June 5, 2007

RE: ADDITIONAL INFORMATION RELEVANT TO CASE 13865 (TARGA REQUEST FOR AUTHORIZATION TO INJECT IN SECTION 27, T22S, R37E; LEA COUNTY, NEW MEXICO) IN RESPONSE TO ISSUES RAISED BY NMOCD ENVIRONMENTAL BUREAU

***Targa Resources, LLC  
Case 13865  
OCD Exhibit No. 1***

Figure 1: 2007 Satellite Photograph Showing Locations of Existing and Proposed Wells

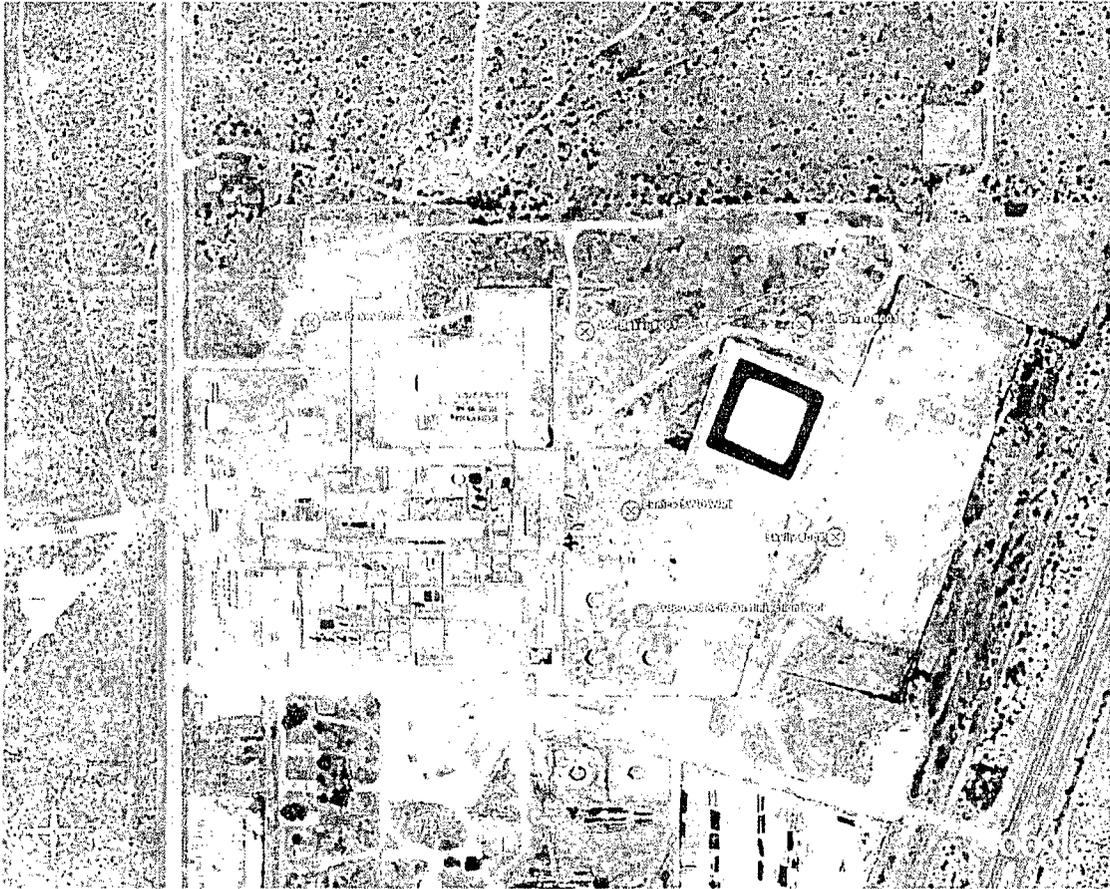
Since the February 1<sup>st</sup> hearing, NMOCD has raised additional questions regarding the potential impacts of the four existing natural gas-storage wells (NGS) located in the vicinity of the proposed AGI well located on the South Eunice Gas Plant. As discussed below, it is clear from the geology of the site and the size, location and relative positions of the salt cavities associated with the 4 inactive NGS wells that there is no potential for impacts to the proposed AGI well nor do they communicate with or impact in any way the existing SWD well.

The relative locations of the existing SWD well, the proposed AGI well and the NGS wells with the associated gas storage cavities in question are shown on Figure 1, plotted on a 2007 aerial photograph. For additional reference, the site and locations are shown on the USGS Eunice 7 ½ Minute Quadrangle map. As shown on Figures 1 and 2, the proposed AGI well will be located approximately 500 feet southwest of the nearest NGS (Skelly #4), and is also over 250 feet from the existing SWD (please recall that this SWD will be plugged and abandoned as it will be replaced by the proposed AGI well).

Therefore Targa would request that the final location of the proposed AGI well be modified to be as shown on Figures 1 and 3 (attached) which would be **2250 FSL, 1200 FWL of Section 27, T 22 S, R 37 E** (essentially 350 feet south of the current SWD well which will be plugged). This assures no potential risk with respect to the gas storage cavities and the well bore of the proposed AGI well and a convenient location with respect to other existing site features.

**Figure 3: Locations of Cross-Sections**

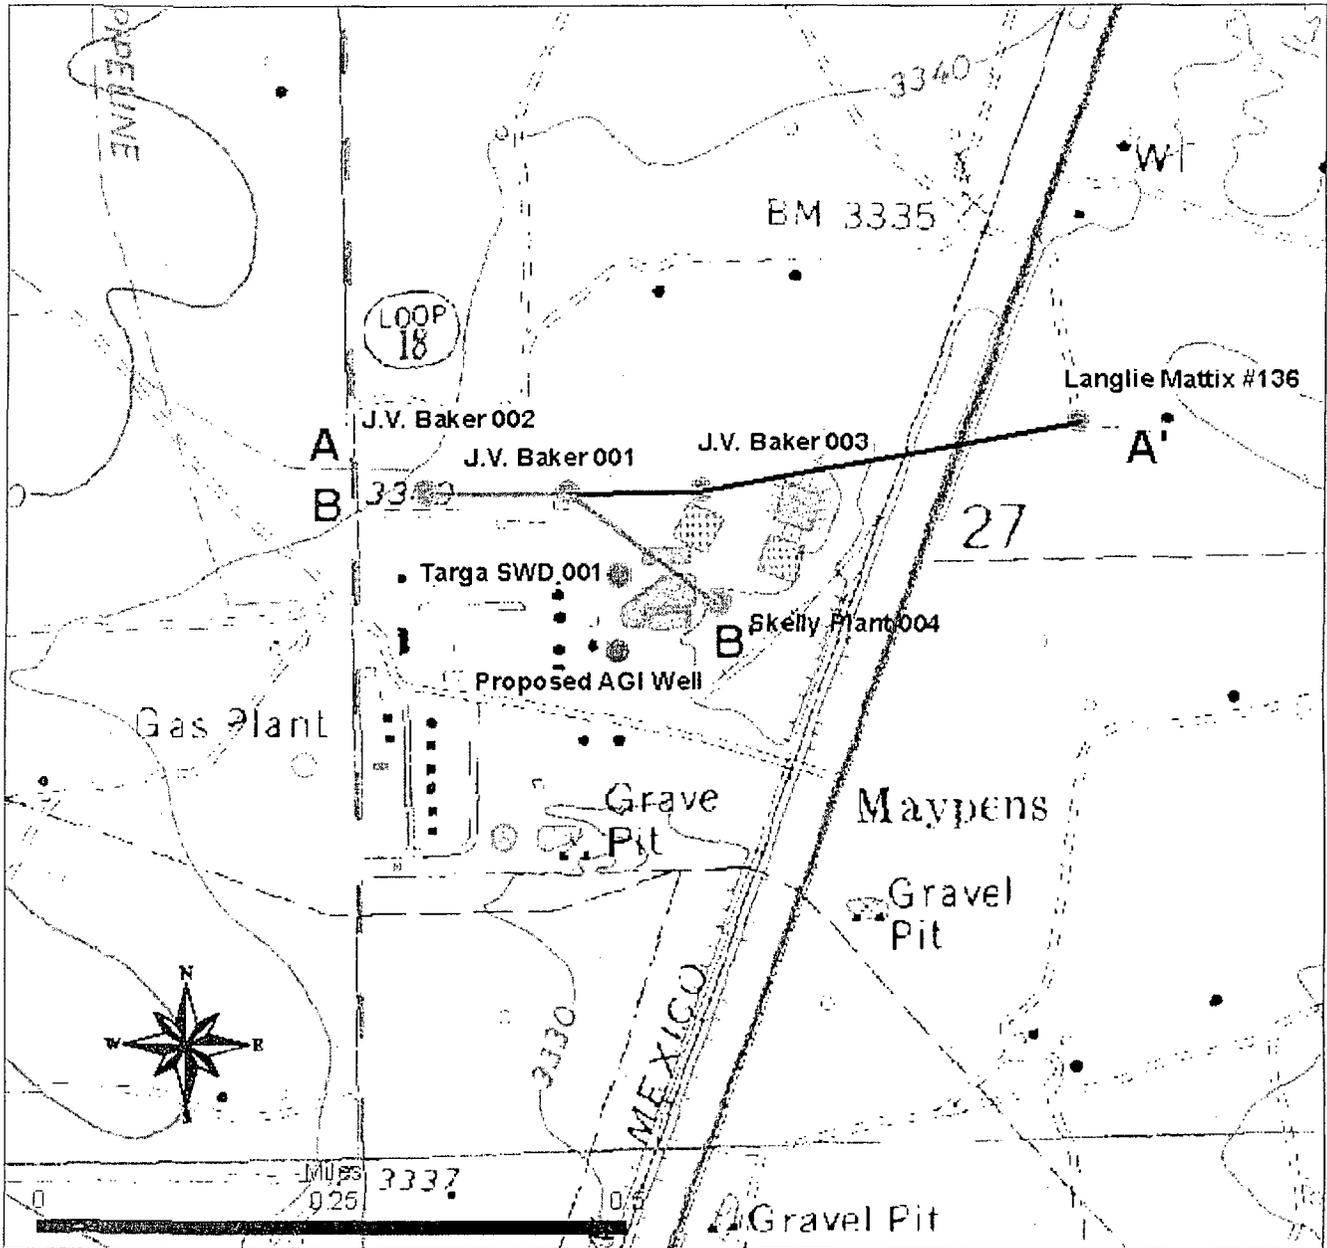
It is critical to understand the small size and capacity of the cavities in the salt associated with each of the NGS wells and it is important to visualize the vertical and horizontal separations between the existing NGS cavities and the proposed AGI zone. Geolex has provided schematic cross-sections to illustrate the relative geological spacing between the inactive gas storage cavities and NGS wells and the proposed location of the AGI well and its associated injection zone. The locations of these cross-sections are shown on Figure 3. Figure 4 is a cross-section along NGS wells J.V. Baker 001, 002 and 003, and includes the projected location of the existing SWD and the Langlie Mattix #136. The Langlie Mattix #136 is added to provide vertical control to the existing SWD injection zone and the proposed AGI zone. This section shows that the storage cavities are stratigraphically and vertically separated by a distance of approximately 2500 feet, including approximately 500 feet of the Salado Formation beneath the cavities. Figure 5, which connects the wells J.V. Baker #1 and #2, as well as Skelly #4 and has the proposed AGI well (located 350' to the SW of the section line) projected onto the section, also clearly shows the separation of the proposed AGI from the salt cavities associated with the NGS wells.
